ZONING PLAN
FOR
BURRUS LANE PROPERTY
COBB COUNTY, GEORGIA
LAND LOTS 228 & 230 - 19TH DISTRICT

PETITION NO: Z-34

ZONING COMMENTS:

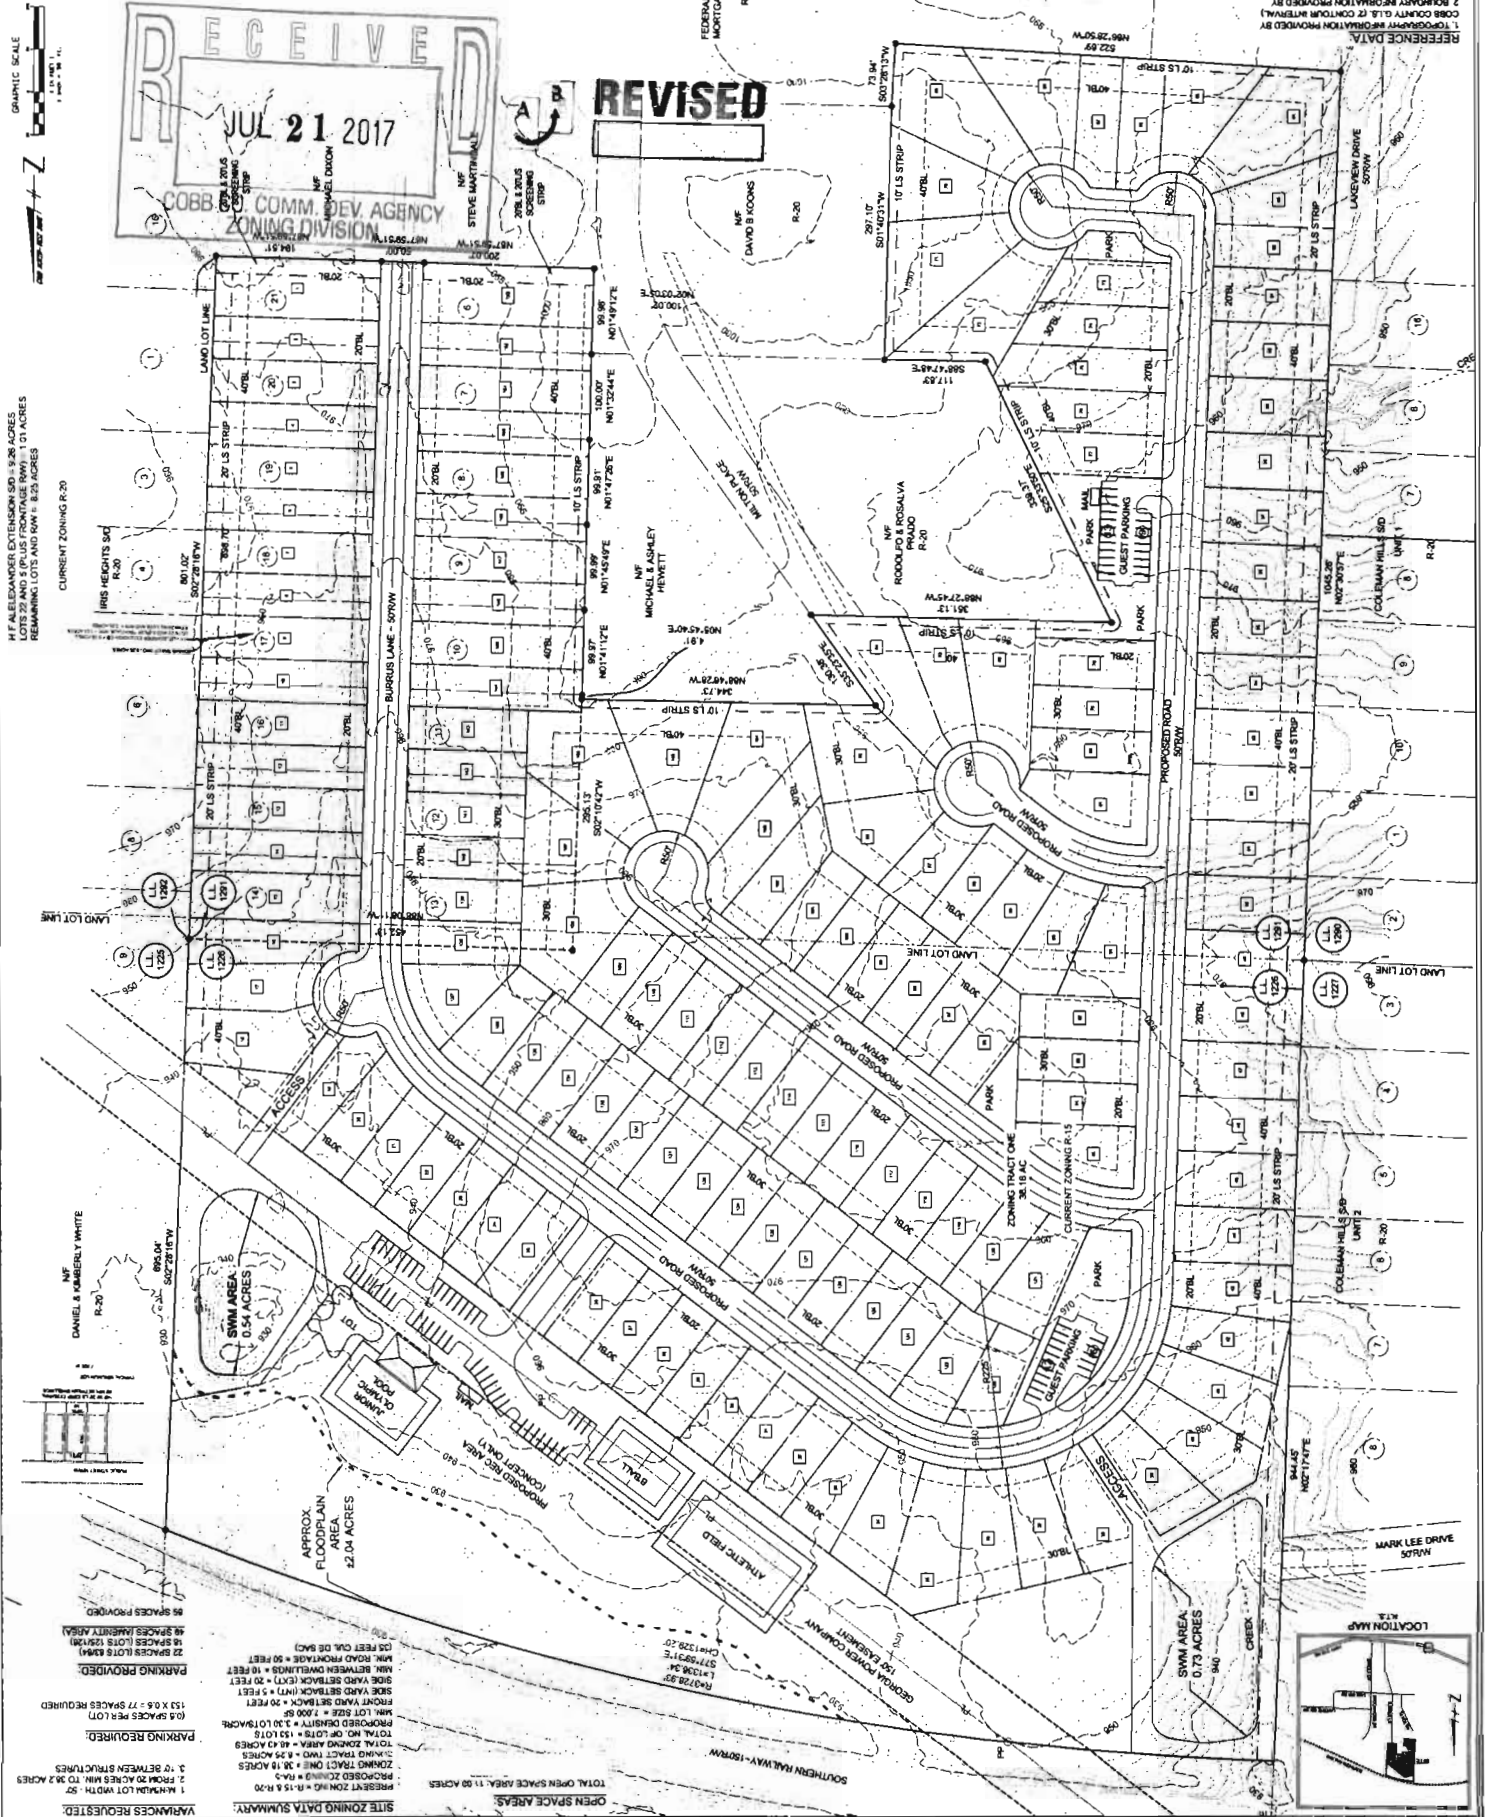
3. Runoff from the upstream adjacent Iris Heights Subdivision to the east must be accommodated through the site. A drainage easement along the rear of lots 1 – 17 will likely be required.

4. Approximately 11.7 acres of the site currently drains into and through the Coleman Hills Subdivision to the west. This is an older subdivision that lacks adequate stormwater infrastructure to accommodate any increase in runoff volume. The applicant has agreed to significantly reduce the runoff discharged to #5489 Janet Lane and to convey all impervious runoff away from #5393 Janet Lane. This will likely require a drainage easement along the rear of lots 40 – 70.

Recommend guest parking be located outside of the right-of-way.

Recommend curb and gutter along both sides and sidewalk along one side of proposed development roadway.
